499-503 CONGRESS STREET - 1916-1969 # 1

499 Congress ST.

A.P. - 503 Congress ot.

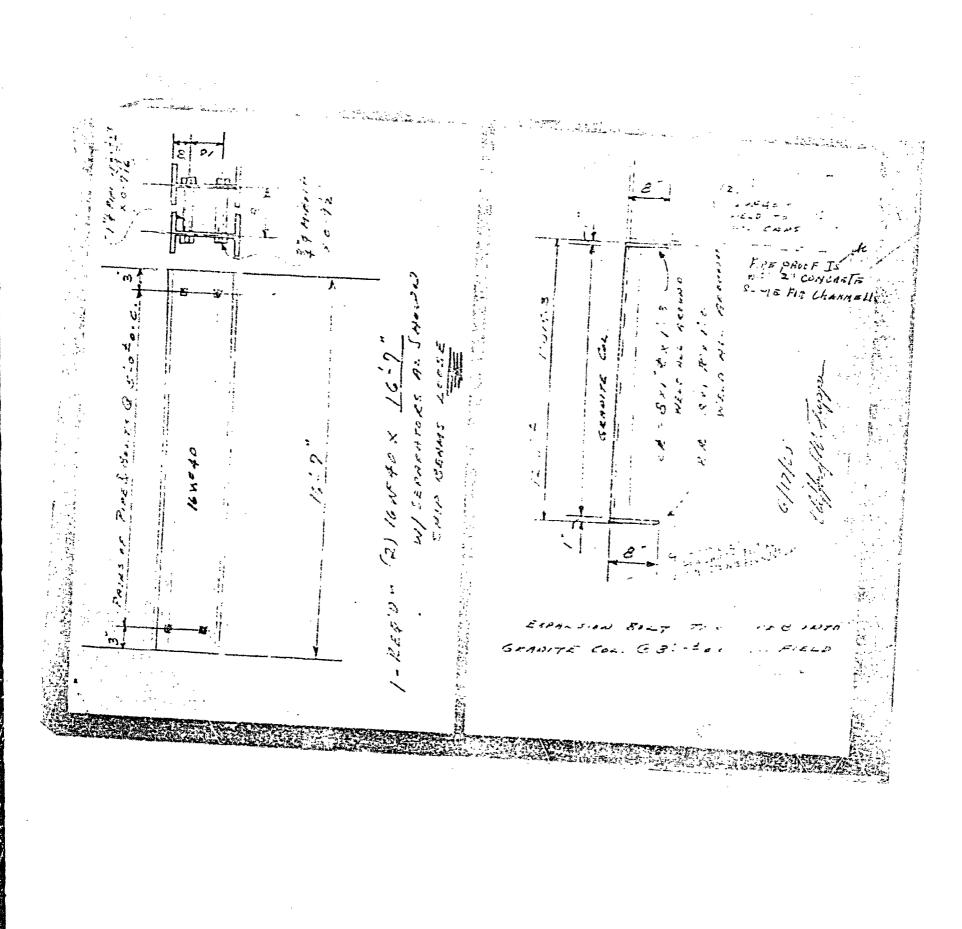
Permit to change the store Front, to finish off walls with sheetrock and to construct non-bearing partitions is being issued subject to plan received with application and building Code restrictions as follows:

- 1. The new lintel of 2-16"-54.7" I's will need to be fireproofed as for 4-hour fire protection. He will need to know how you intend to attain this protection.
- 2. Defore we may approve the installation of the illuminous plastic ceiling below the sprinkler heads, information rust be submitted to this office pertinent to type, ramufacturer, method of installation, and that it is a type approved for use under automatic sprinklers.

AP- 501 Congress Street

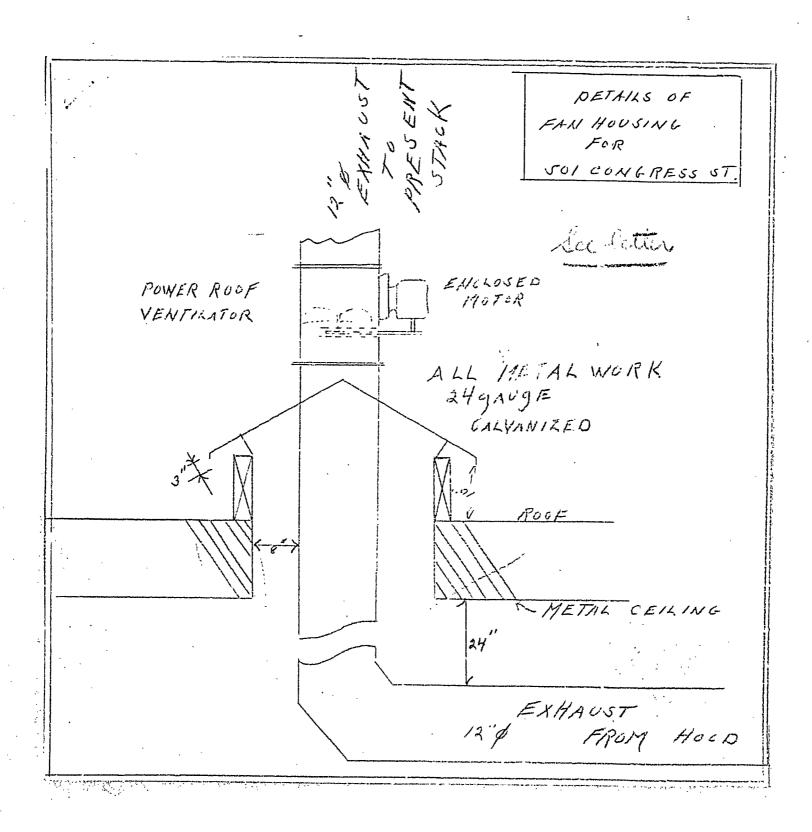
Permit for alterations to hood and ventilating system in kitchen of restaurant at the above named location is issued herewith based on plans filed with application for permit but subject to the condition that construction will be provided as outlined below in order to meet Building Code requirements:

- 1. Metal of new exhaust duct work is to be no less than 18 gauge steel or 20 gauge stainless steel. - See Section 602-4-2 of Code.
- 2. A metal thimble at least 12 inches greater in diameter than the duct, spaced out at least one inch from the woodwork at the cides of the opening in roof construction, and extending from the underside of the ceiling to a point at least 9 inches above the surface of the roof is to be provided in opening in mone story roof through which duct passes. Wooden curb around opening in roof is to be completely covered with sheet metal. If desired, the six air inch space between thimble and duct may be filled with mineral wool or equal incombustible insulating material, but with the thimble at the top left open to the atmosphere.
- The exhaust duct is to extend to a point above any window openings in the adjacent wall.

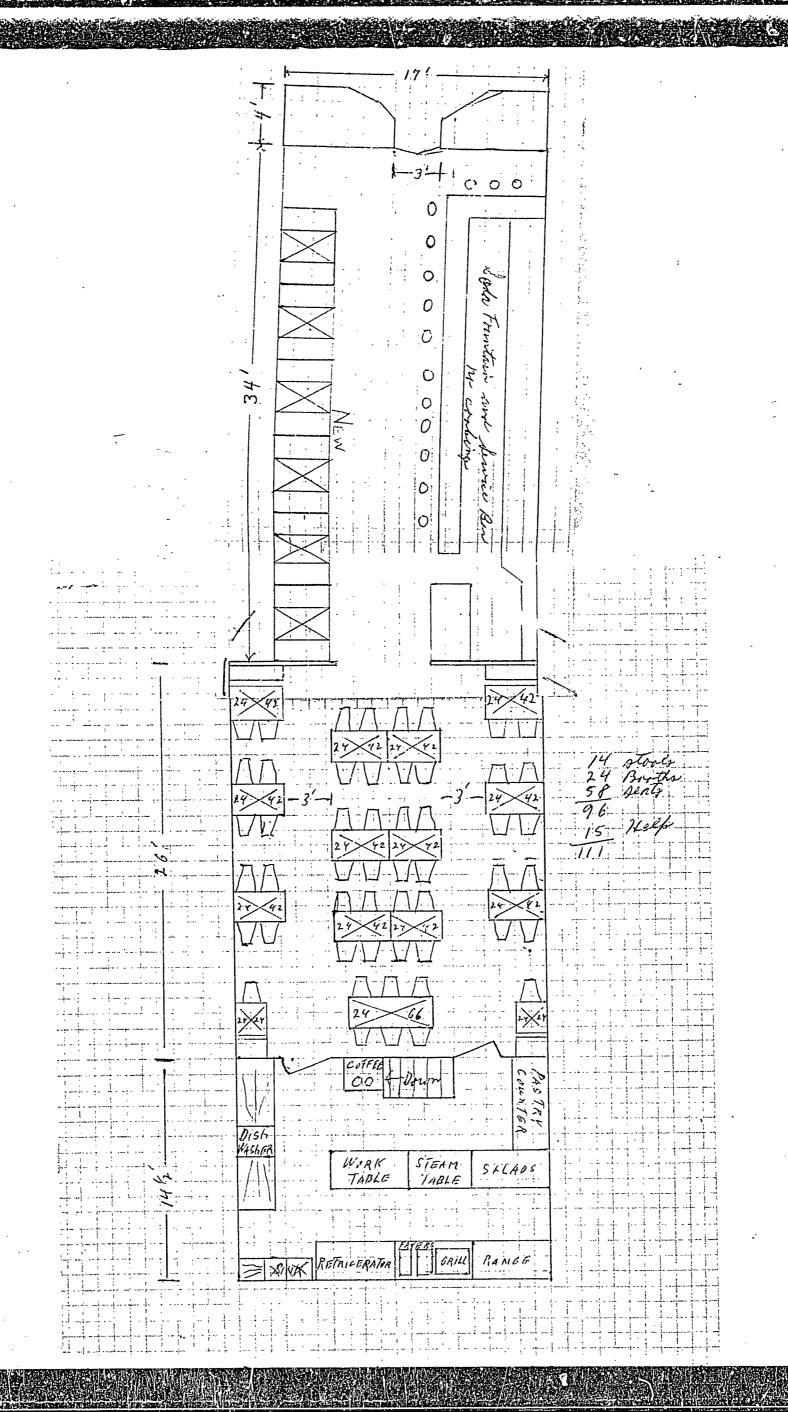
Plan filed with application for permit for alterations to front of restaurant at the above named location does not furnish information needed to show compliance with Building Gode requirements. Dotails in question are as follows:

- 1. What is backing and thickness of ashlar stone veneer to be and how is it to be anchored to backing to meet Code requirements?
- 2. What is construction to be above top of show window and what is material and size of header at top of show ______ Lee pland window to be?
- 3. In what direction is new entrance door to swing and is it to be equipped only with a vestibule latch set or equivalent without any other locking devices on it?
- h. Is recessed entrance to be in some location as the yell existing one or will additional floor framing be needed?
- 5. What is linted to be for plate glass window? Seeplan
- 6. Will any of new work project firther from wall of building than existing construction?
